A74387_AM7MG_VIA Update 130909

Dennis Lake Viewpoint

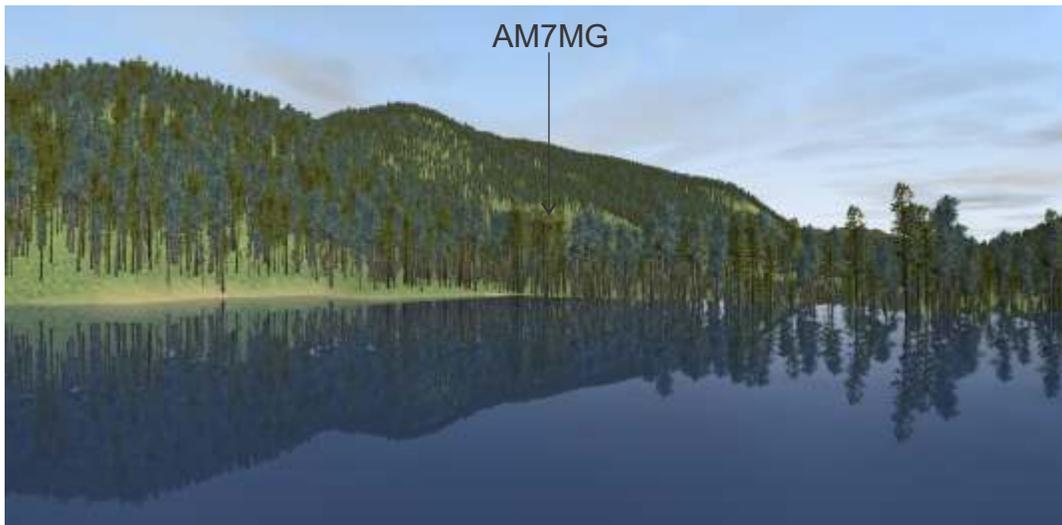
“BCTS manages for the scenic areas in the Clearwater inventory, although not legally required to do so.”

“The AREA 6 report (prepared by RDI in 2012) didn’t really address cut block AM7MG as the viewpoints were from the highway only”.

“This block falls in a polygon with VSC3. We have to meet PR or M”

“My evaluation of the block as depicted in the A74387_AM7MG_Draft VIA-1 image, and subsequent high-resolution images presented above (from a point near the top end of the lake) is that it is well-designed, meets lines-of-force, benefits from shoreline screening, and easily meets the visual quality class of Partial Retention, with the latitude of Modification, if required, given the range offered by VSC3.”

(RDI tested visibility from the highway only in its initial report and found the block to be non-visually sensitive - KF)
